# PUBLICATION INDEX

### SGS 2-33

K & L SOARING, LLC  
5996 STATE ROUTE 224  
CAYUTA, NY 14824

BULLETIN NO. SA-001.6\*

**FIGURE 1 – ENGAGEMENT OF TOW HOOK INTO RELEASE ARM**

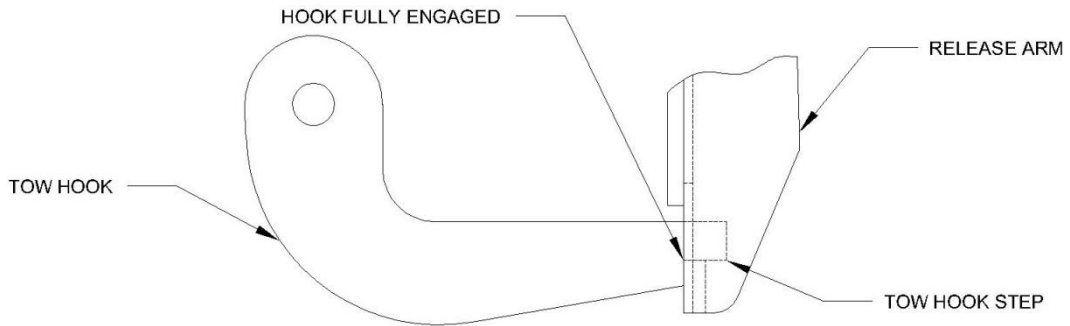
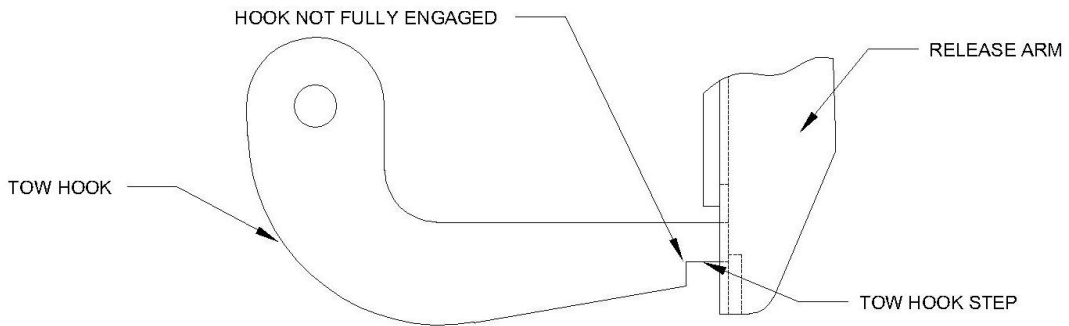
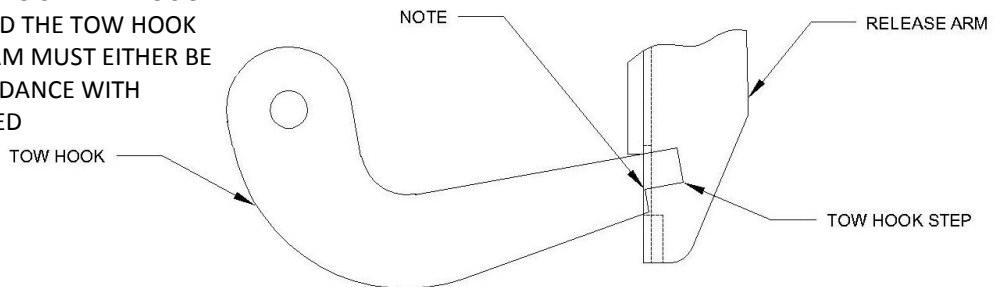
- Proper engagement of the tow hook into the release arm is shown in Figure 1, View A, and Figure 4. Excessive wear of the tow hook step could result in improper engagement. Figure 2 of this bulletin provides inspection data and wear limits for the tow hook. Tow hooks which do not meet the specified limits must either be reworked to obtain dimensions (as specified in Figure 2) or replaced.
  - If tow hooks is able to slide into the release arm, beyond the tow hook step, as shown by Figure 1, View C, the release arm must either be reworked with a slug as specified in Figure 3, or replaced.
- c. Inspect tow hook for wear in accordance with Figure 2 of this bulletin.

- Figure 1 shows the proper attachment of the tow hook into the release arm. Note that the step of the tow hook should seat against the release arm. The tow hook step must fully engage the release arm to allow the release assembly to function properly. The tow hook must not be allowed to extend through the release arm beyond the step on the hook as shown in Figure 1, View C.

IF TOW HOOK IS ABLE TO SLIDE THROUGH RELEASE ARM, BEYOND THE TOW HOOK STEP, THE RELEASE ARM MUST EITHER BE REWORKED IN ACCORDANCE WITH FIGURE 3, OR REPLACED

- g. If tow hook is able to travel too far inboard as shown in Figure 1, View C, disengage tow hook from release arm and measure the length of the release arm slot
- h. If dimension is less than 0.66 inch, rework release arm by welding on 1B-217-19 slug at location shown in Figure 3. (Release arm may be replaced as an alternate to welding on slug)
- i. If length of release arm slot is greater than 0.66 inch, replace release arm.
- j. Perform a thorough inspection of the tow hook installation in accordance with the 100 hour inspection requirements listed in Table 2 of this bulletin.
- k. Repair or replace unserviceable component(s), as required
- l. Record compliance with Part I of this Service Bulletin in Aircraft Log Book.

FIGURE 2 – TOW HOOK INSPECTION AND REWORK (SHEET 1 OF 2)

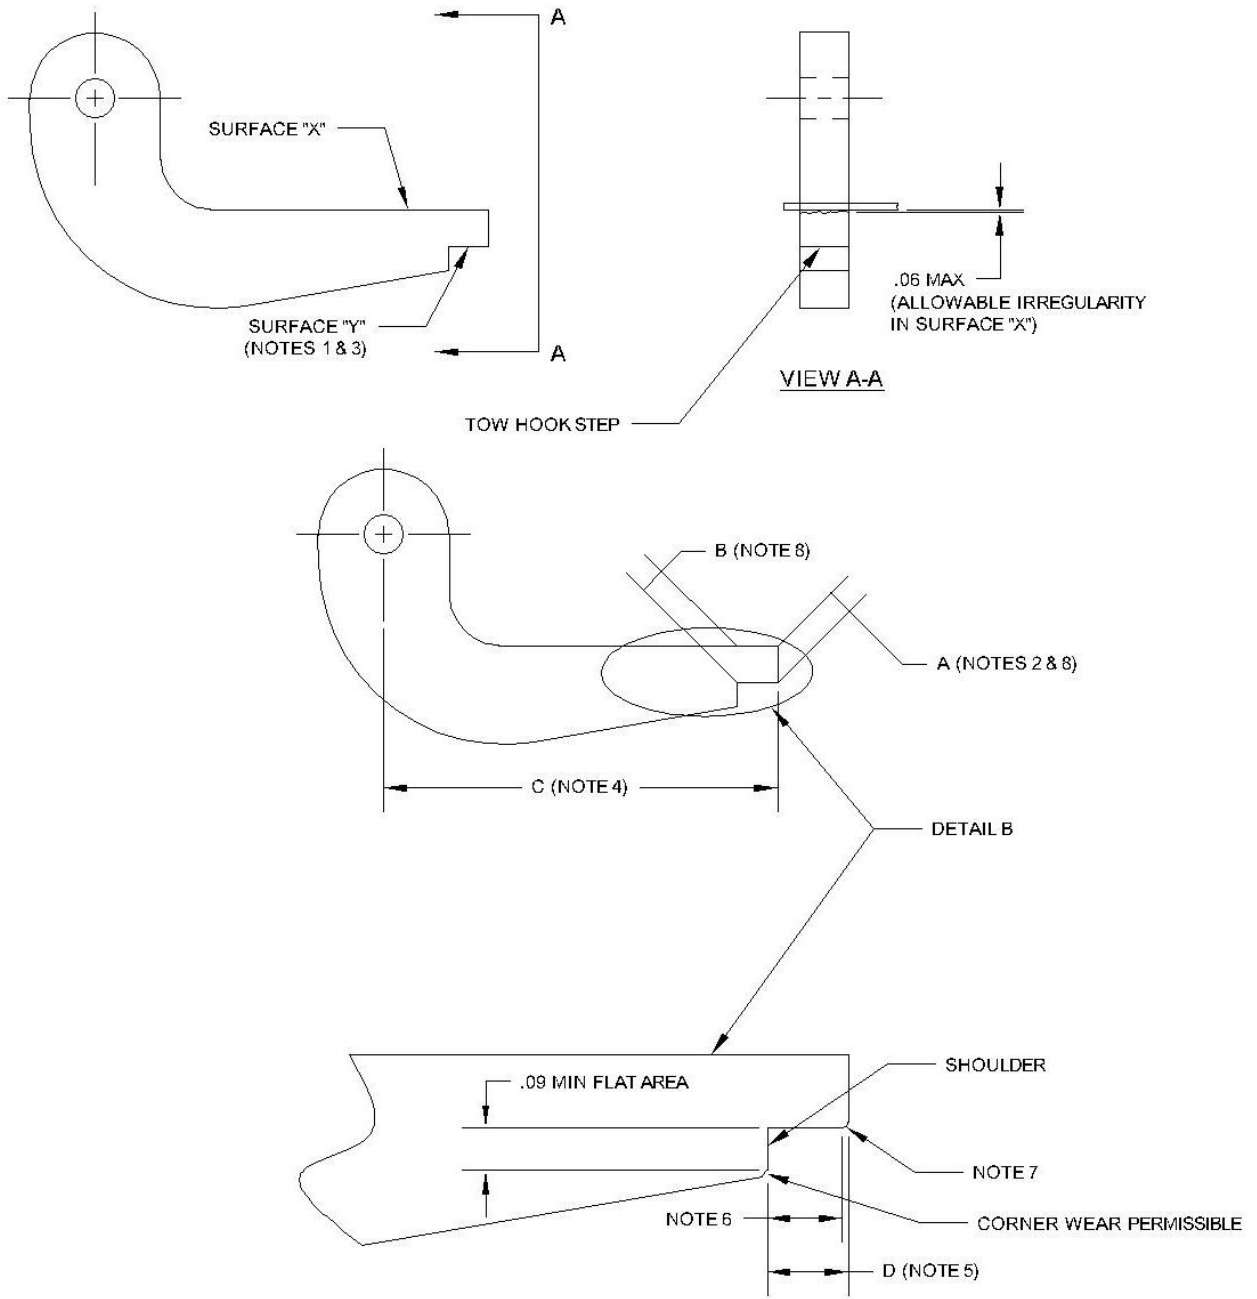
- d. If tow hook dimensions are not within limits specified in Figure 2, either rework the tow hook to obtain dimensions (as specified in Figure 2) or replace it with a new or serviceable, used tow hook
- e. Engage tow hook into release arm. Ensure that the tow hook properly engages as shown in Figure 1, View A.
- f. If tow hook is unable to completely engage (shown by Figure 1, View B) shorten the rubber bumper stop between the release knob and the instrument panel to allow the release assembly to close further.

1. IF WEAR OCCURS ON SURFACE "Y" IT MUST BE POLISHED FLAT WITHIN TOLERANCES PROVIDED IN FIGURE 2 (SHEET 1). IF THE HOOK CANNOT MEET THESE REQUIRED DIMENSIONS IT MUST BE REPLACED. UNDER NO CONDITIONS SHOULD SURFACE "X" BE POLISHED OR MACHINED TO CHANGE ITS ANGLE.

2. DIMENSION "A" ON STD 10232-001 HOOK SHALL BE .21 INCHES MIN. & .28 INCHES MAX. DIMENSION "A" ON STD 1A218-1A, STD 1B221-3, & R-200-9A HOOKS SHALL BE .25 INCHES MIN. & .31 INCHES MAX.

3. SURFACE "Y" MUST REMAIN FLAT, SMOOTH, AND WITHIN TOLERANCES SHOWN ON SHEET 1. (SEE ILLUSTRATION).
4. DIMENSION "C" ON STD 10232-001 HOOK SHALL BE  $2.06 \pm .03$  INCHES. DIMENSION "C" ON STD 1A218-1A, STD 1B221-3, & R-200-9A SHALL BE  $3.00 \pm .03$  INCHES.

5. DIMENSION "D" ON STD 10232-001 HOOK SHALL BE  $.25 \pm .03$  INCHES. DIMENSION "D" ON STD 1A218-1A, STD 1B221-3, & R-200-9A SHALL BE  $.31 \pm .03$  INCHES.

6. HOOK MUST REMAIN FLAT IN THIS AREA FOR A MIN. OF .21 INCHES FROM SHOULDER OF HOOK.
7. WEAR OUTSIDE OF THE .21 MIN. FLAT AREA IS PERMISSABLE.
8. DIMENSION "B" MUST BE EQUAL TO DIMENSION "A", OR LESS THAN DIMENSION "A" BY NO MORE THAN .015 INCHES AND CANNOT BE GREATER THAN DIMENSION "A".

9. ALL SURFACES EXCEPT SURFACE "X" MAY BE FILLED TO OBTAIN REQUIRED DIMENSIONS.

**FIGURE 3 - REWORK OF RELEASE ARM**

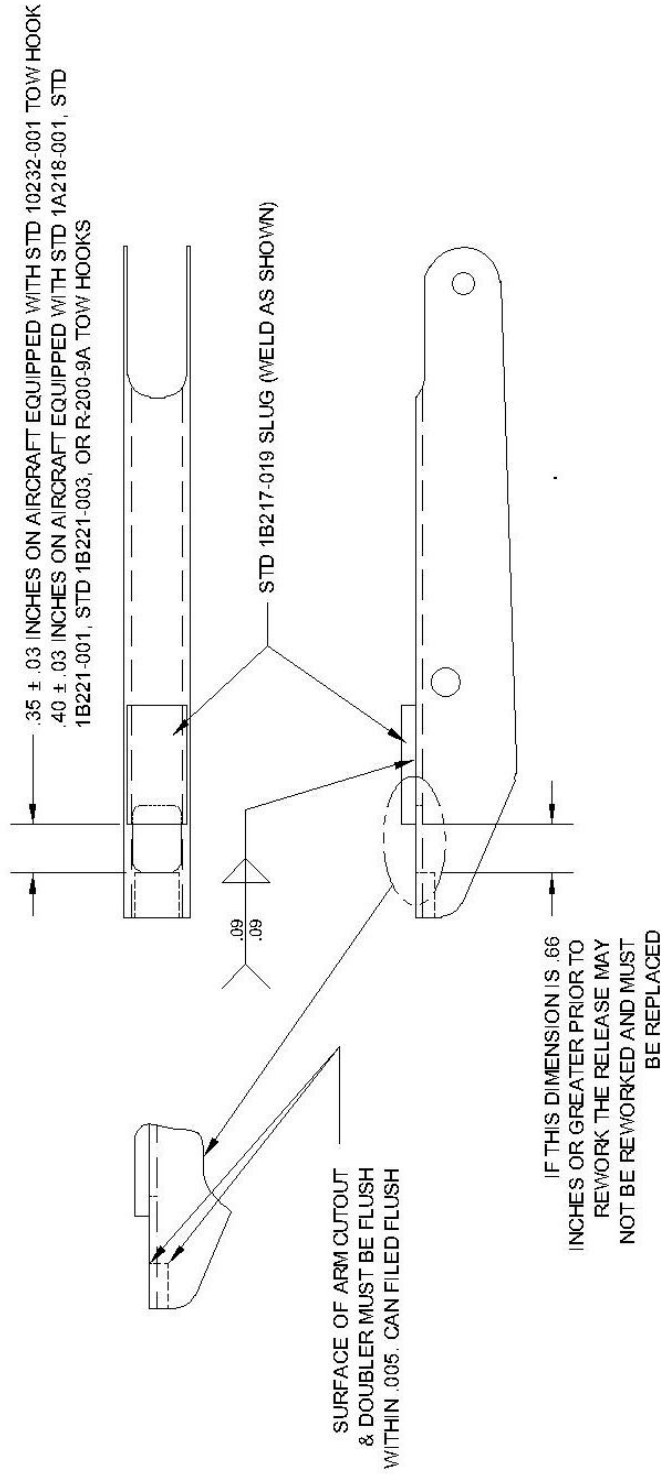
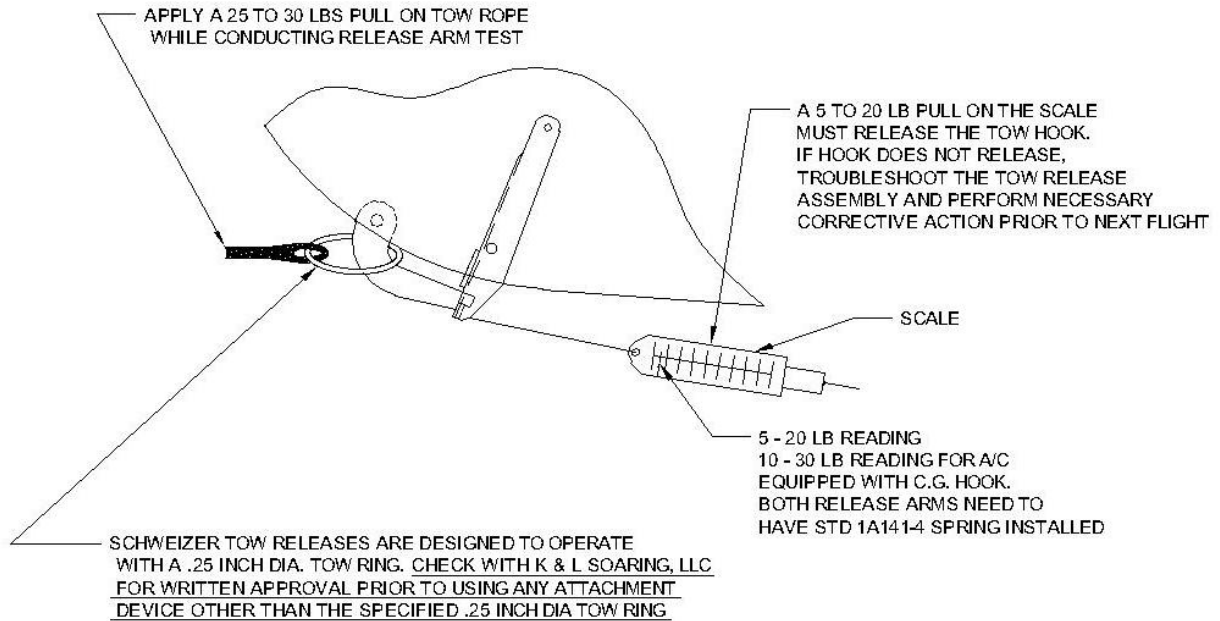
**NOTE: ALL TOW RELEASE ARMS MUST BE REWORKED AS SHOWN ABOVE OR  
 REPLACED WITH THE PROPER SUPERSEDING ARM AS SPECIFIED IN TABLE 1**

**NOTE: STD 1B217-019 SLUG IS AVAILABLE FROM K & L SOARING, LLC  
 0.125 X 0.5 X 1.0 4130N STEEL**

FIGURE 4 - PULL TEST OF TOW RELEASE ASSEMBLY

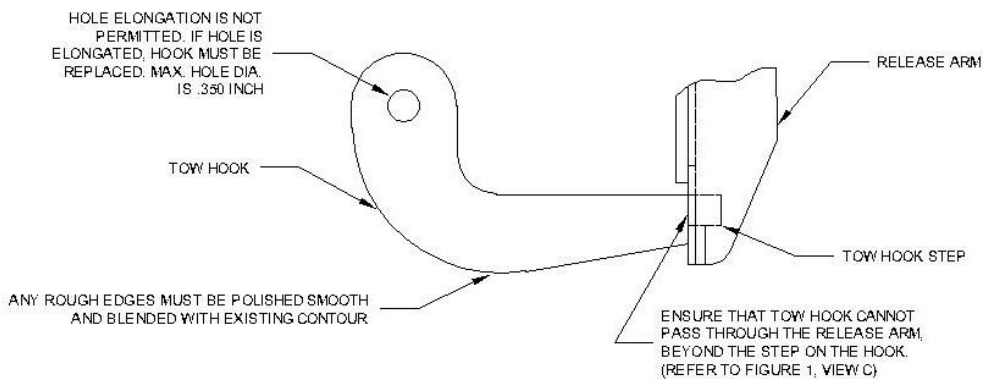
Perform a release check for proper release tension in accordance with Figure 4.			X
Lubricate attach hardware for tow hook and release arm.		X	X
Lubricate guide-tubes in release control with dry stick type lubricant.		X	X
Insure that tow hook moves freely on pivot bolt.	X	X	X

NOTE: IF RELEASE LOADS ARE TOO HIGH WITH C.G. SYSTEM IT IS PERMISSIBLE TO ADD A LINK TO SHORTEN STD 1A141-2 SPRING. LINK SHOULD BE MADE AS SHOWN BELOW. IF REQUIRED THEY SHOULD BE ADDED TO BOTH RELEASE ARMS TO BALANCE BOTH RELEASE SPRINGS

Figure SA-008-1 Vertical Fin Forward Attach Point

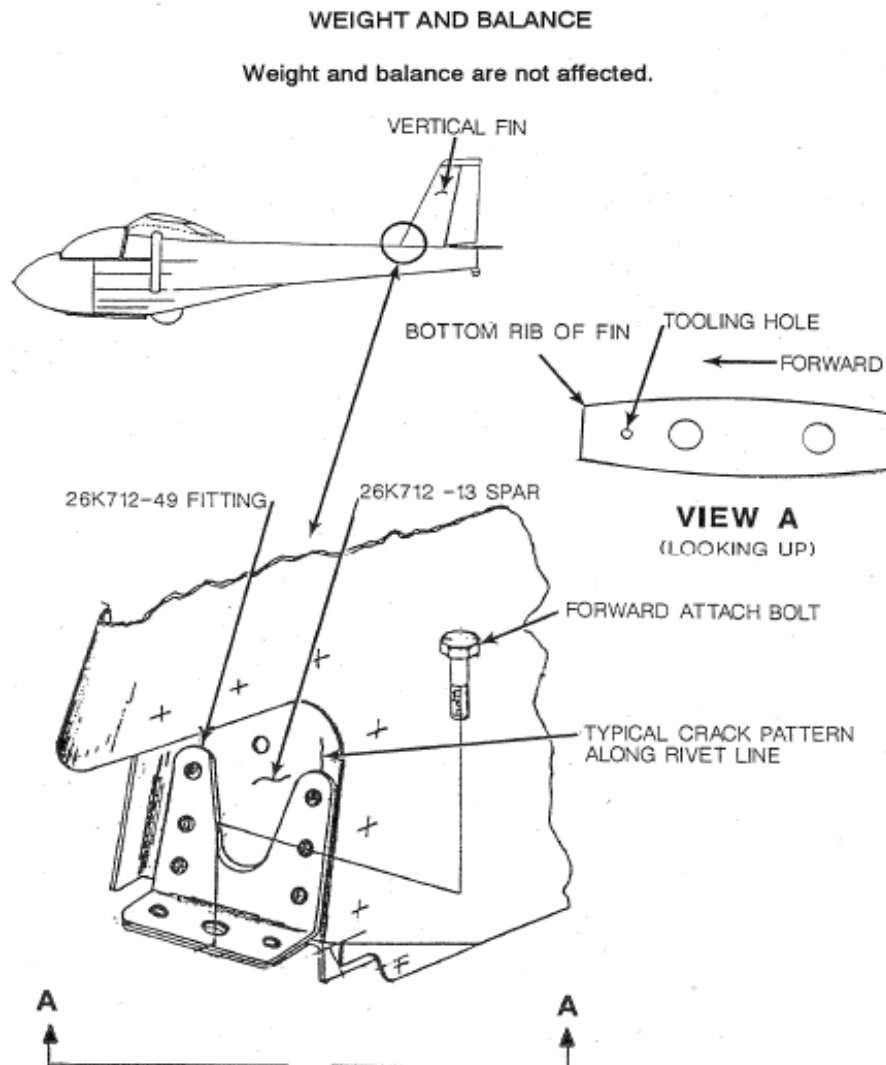
PREFACE: Field reports indicate that cracking was discovered in the forward spar of the vertical fin, and the forward fin attach bolt was loose. This Service Bulletin provides the inspection procedure to check for cracking and hardware security.

- A. Remove access cover from the lower edge of the vertical fin, to expose 26712-49 fitting (Figure SA-008-1).
- B. Visually inspect for cracks in the 26712-13 spar propagating from behind the -49 fitting and check for security of the forward attach bolt. Perform the following steps, as applicable:
- C. If cracking is found, contact K&L Soaring for repair instructions (607) 594-3329.

- D. If cracking is suspected, but not confirmed, or if the forward fin attach bolt is loose, perform the following:
1. Remove the vertical fin from the aircraft (2-33 & 2-33A Manual)
  2. Enlarge the forward tooling hole in bottom rib of vertical fin to one inch maximum (Figure SA-008-1, Detail A). Use the enlarged hole for visual access to inspect for cracking on the back side of the -13 spar. If cracking is found, perform step C above.
  3. Install vertical fin on aircraft (2-33 & 2-33A Manual)  
FAA AD Note 76-13-11 was previously performed, remove plugs from above
- E. Ensure that forward fin attach bolt is tight; then install access cover on vertical fin.
- F. Record compliance with this Service Bulletin in the aircraft records.

Figure SA-010-1. Vertical Fin Rear Spar Inspection

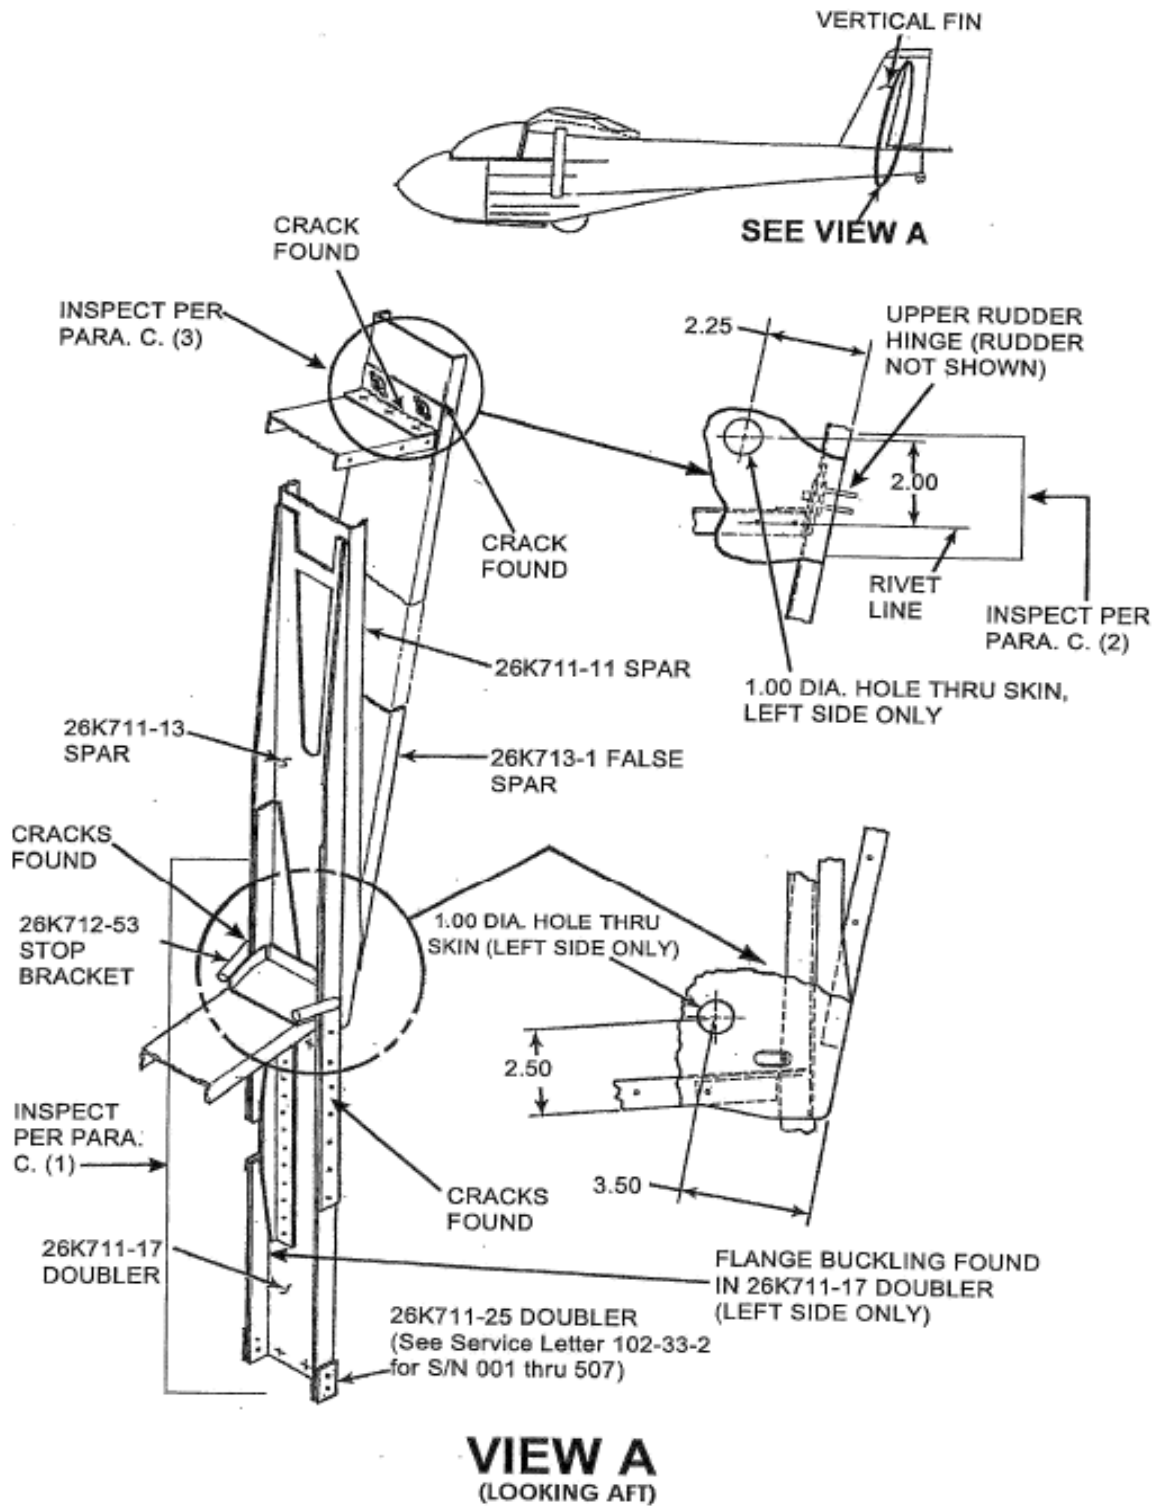
There have been field reports of damage found on the rear spar of the vertical fin. Some of these reports involved high time sailplanes (over 11,000 hours) with cracks in the spar (and spar doubler). Cracks were found on the left-hand spar flange (and doubler) just below and under the fin skin running around the mold line towards the upper left hand fin/fuselage attach point. Additional cracks were found in the 26K713 false spar and rib clip angle under the uppermost rudder hinge. On another sailplane, cracks were found above the rudder stop fitting. (See Figure SA-010-1)

- A. Remove the fin/fuselage gap and hand hole covers.
- B. Drill the inspection hole(s) in the fin skin according to steps (1) and (2) below. (These holes are used to facilitate the inspections set forth in Paragraph C that follows)

1. Drill a 1.00 inch diameter hole in the area of the rudder stop fitting, in the location specified in Figure SA-010-1.
  2. Drill a 1.00 inch diameter hole in the area forward of the upper rudder hinge, in the location specified in Figure SA-010-1.

- C. Using a mirror and flashlight, inspect the following: (Figure SA-010-1)
  1. Inspect the rear spar assembly, from the bottom to above the rudder stop fitting, for evidence of buckling, cracking, or other deterioration. Check the four attach bolts for tightness.

2. Inspect the false spar (aft face) around the upper rudder hinge. Look specifically for any cracking that emanates from under the hinge doubler and may only have traveled 1/8 inch or less beyond the doubler.

3. Through the upper hinge inspection hole, inspect the clip angle and false spar for cracking forward of the upper rudder hinge (Figure SA-010-1)
- D. If damage is found, remove the aircraft from service and contact K&L Soaring for repair instructions. (607) 594-3329

SUBJECT: Possibility of Tow-line-ring fouling  
Model SGS 2-33, Ser. No's 1 thru 40

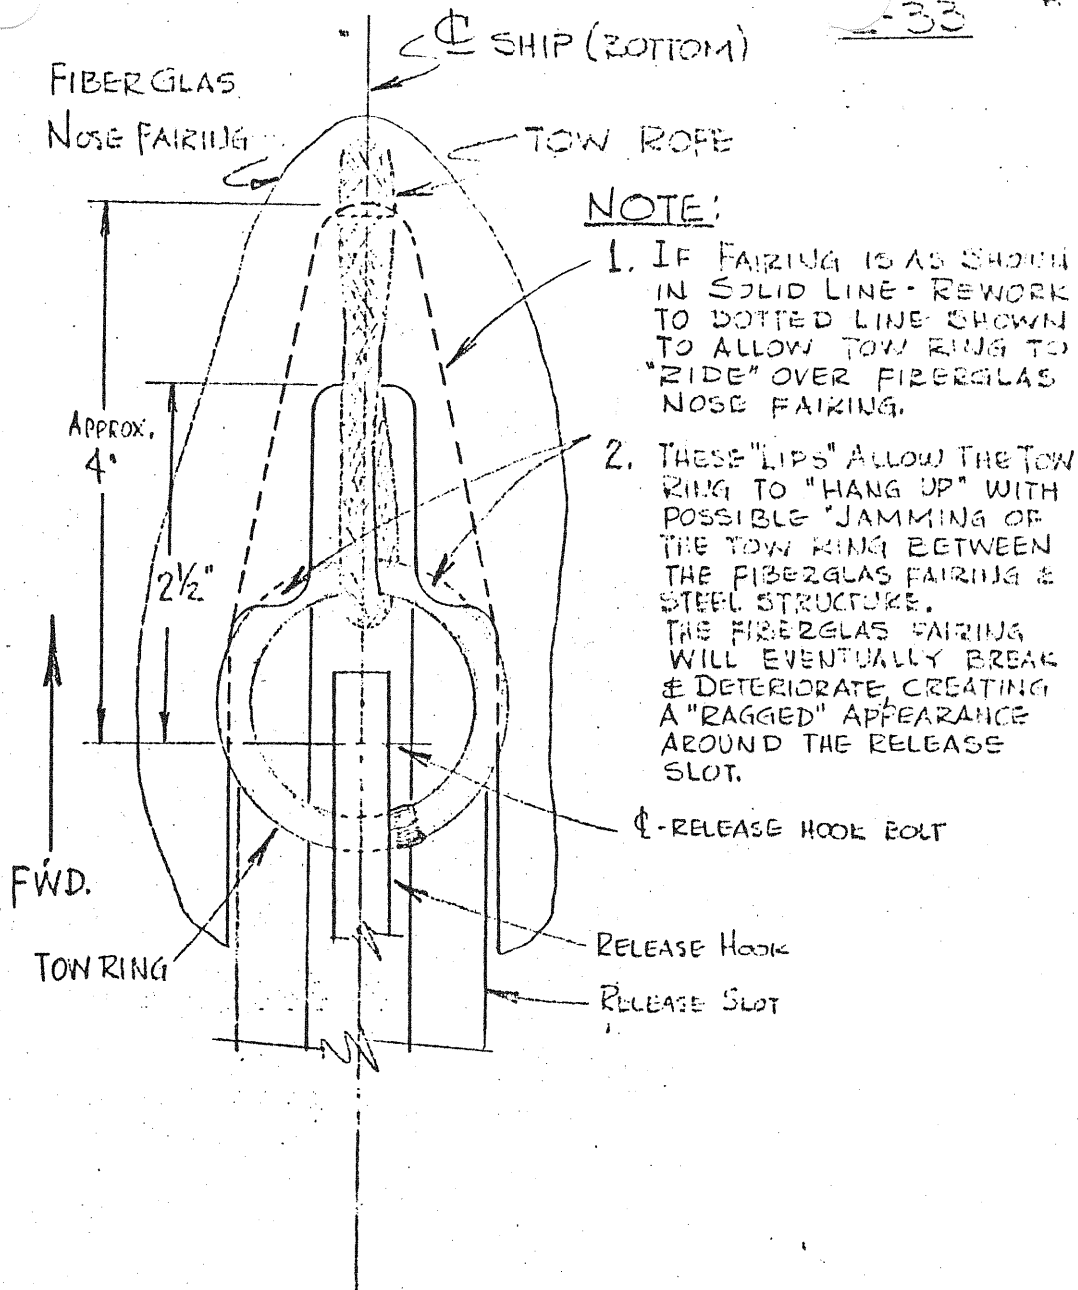
It has been reported that the cut-out in the fiberglass nose fairing, forward of the tow hook is shaped so that there is a possibility that the tow ring could become caught under the corners of the cut-out when the tow ring is released from the hook.

Should this happen, the forces involved would simply tear the tow ring from under the fiberglass fairing and not endanger further flight, however damage such as this is obviously undesirable.

To prevent the above possibility it is recommended that the fairing opening be reworked in accordance with Schweizer sketch No. 4550A, copy of which is attached to this letter.
